CHANGE BULLETIN 01

F.G.A. No. 21003

ROOMS TO GO – OFFICE RENOVATION & EXPANSION

January 20, 2022

SHEET NUMBER
M1.10C

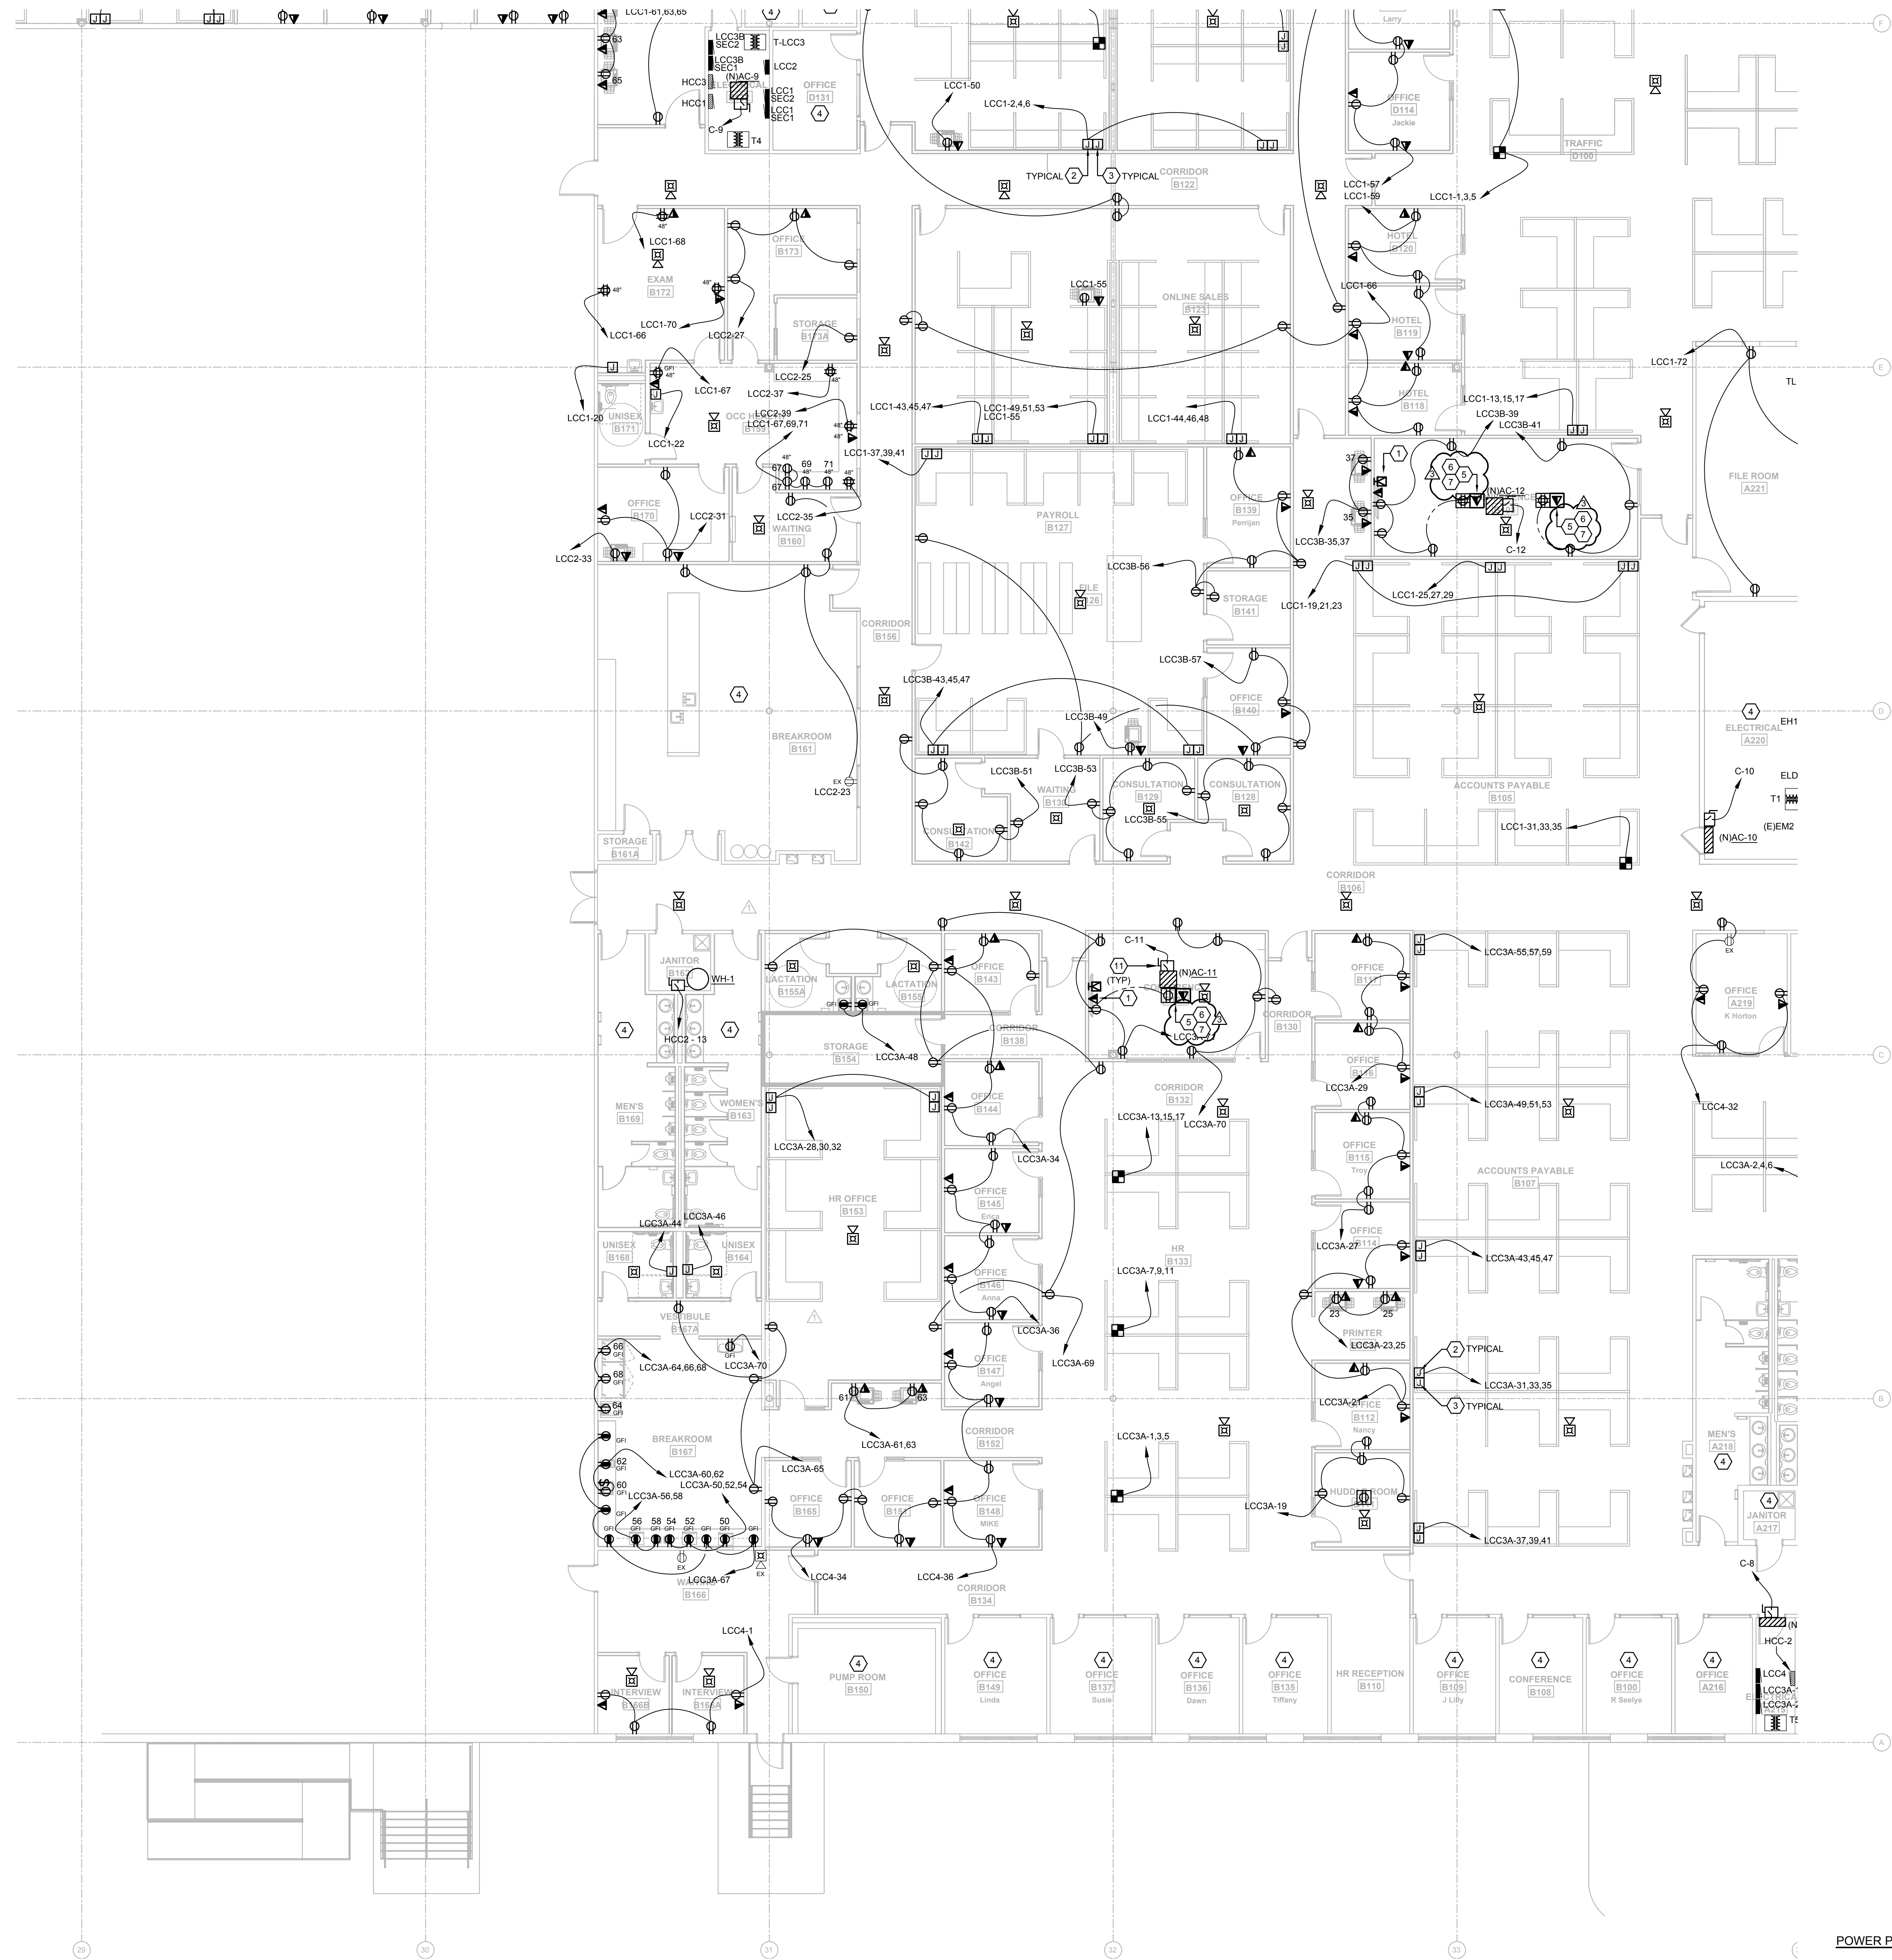
Dwg No	Description	Remarks
M1.10C	HVAC PLAN – C	<ul style="list-style-type: none"> Removed all ductwork connected to RTU-49. Removed new ductwork from a portion of RTU-80 in work area C137, break room C139 and File C138. Connected existing duct to new duct main.
MD1.10C	DEMOLITION HVAC PLAN - C	<ul style="list-style-type: none"> Added existing supply and return ductwork of RTU-80. Showed which portions to demo as needed.

SHEET NUMBER
E1.10C

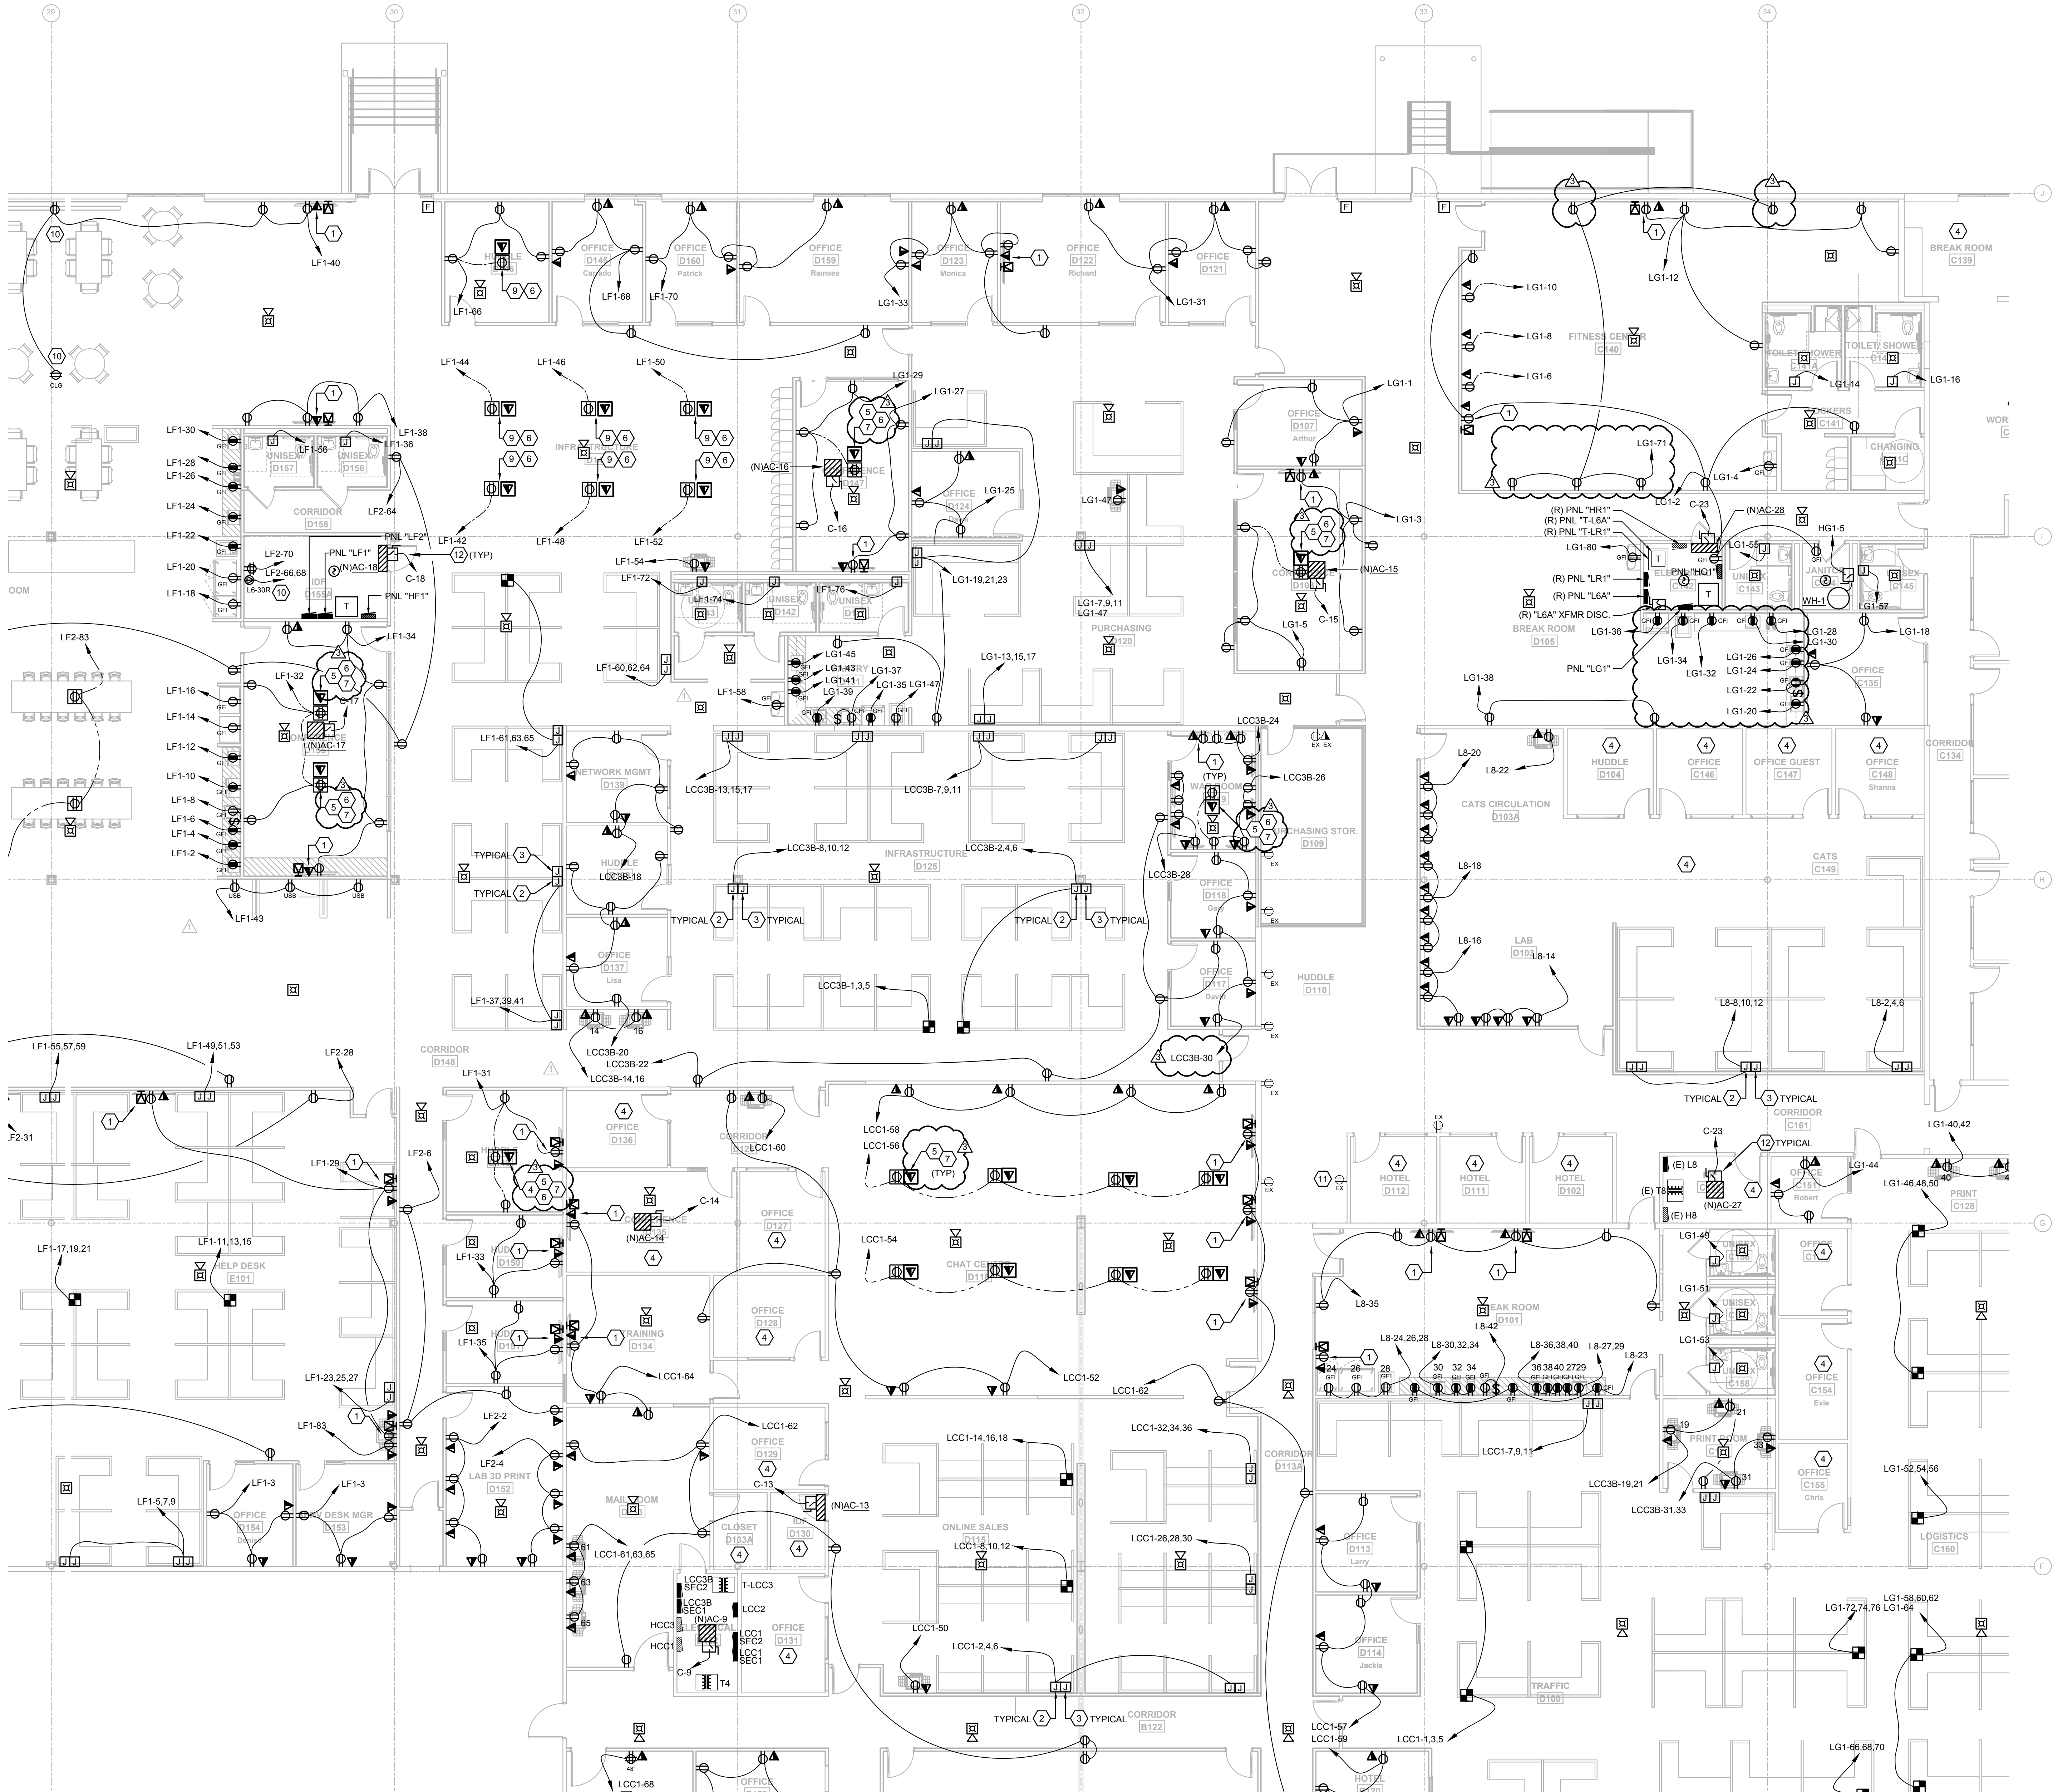
Dwg No	Description	Remarks
E1.10A	POWER PLAN – A	<ul style="list-style-type: none">Added keynotes regarding conduit for floorboxes
E1.10B	POWER PLAN – B	<ul style="list-style-type: none">Added keynotes regarding conduit for floorboxes
E1.10C	POWER PLAN – C	<ul style="list-style-type: none">Added general use receptacles to Fitness Center C140Adjusted Break Room D105 counter receptacles and showed as above/below counter as applicableUpdated device layout to new floor plan of Advertising Office C113 and Executive Area C105
E1.10D	POWER PLAN – D	<ul style="list-style-type: none">Overlap with Area C in Fitness Center C140 and Break Room D105Added keynotes regarding conduit for floorboxesUpdated circuit assigned to Office D117 and D118 to match panel schedule
E1.10E	POWER PLAN – E	<ul style="list-style-type: none">Added keynotes regarding conduit for floorboxes
E2.10A	LIGHTING PLAN – A	<ul style="list-style-type: none">Removed linear fixtures, added downlights in Corridor A202 per architectural RCPShifted linear fixtures in wider section of Corridor A202 to center of wider section per architectural RCPAdded occ sensor for auto-off control in Huddle A171Changed linear fixtures to downlights in Corridor A175 per architectural RCPChanged linear fixtures to downlights in Corridor A192 per architectural RCPAdded occ sensors for auto-off control in downlight section of Corridor A192
